## Product Change Notice (PCN)

PCN Number: **PCN-0456164R**

Product(s) Affected: **PJ-036D**

PREVIOUS CUI DEVICES DETAIL / IMAGE	NEW CUI DEVICES DETAIL / IMAGE

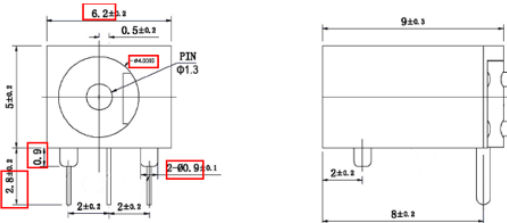
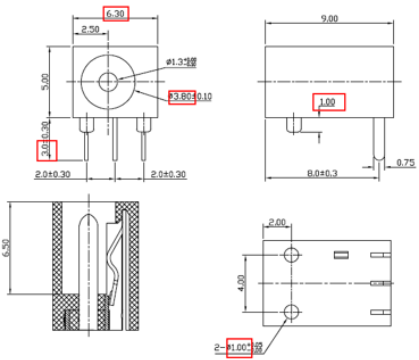
Description of Change: **New Factory Location. Product re-engineered for improved manufacturability and production yield. See image below for reference and check CUI Devices website for updated drawing. Cosmetic differences may be visible and not affect the form fit and function of the product.**

PREVIOUS CUI DEVICE'S DETAIL / IMAGE			NEW CUI DEVICE'S DETAIL / IMAGE		
DESCRIPTION	MATERIAL	PLATING/COLOR	DESCRIPTION	MATERIAL	PLATING/COLOR
center pin	brass	silver	center pin	brass	silver
terminal 1	brass t=0.25	silver	terminal 1	brass t=0.25	silver
terminal 2	brass t=0.25	silver	terminal 2	SUS301 t=0.25	silver
terminal 3	brass t=0.25	silver	terminal 3	brass t=0.25	silver
housing	PBT (UL94V-0)	black	housing	PPA (UL94V-0)	black

MATING PLUG  
Jack Insertion Depth: 6.4 mm

MATING PLUG  
Jack Insertion Depth: 6.5 mm
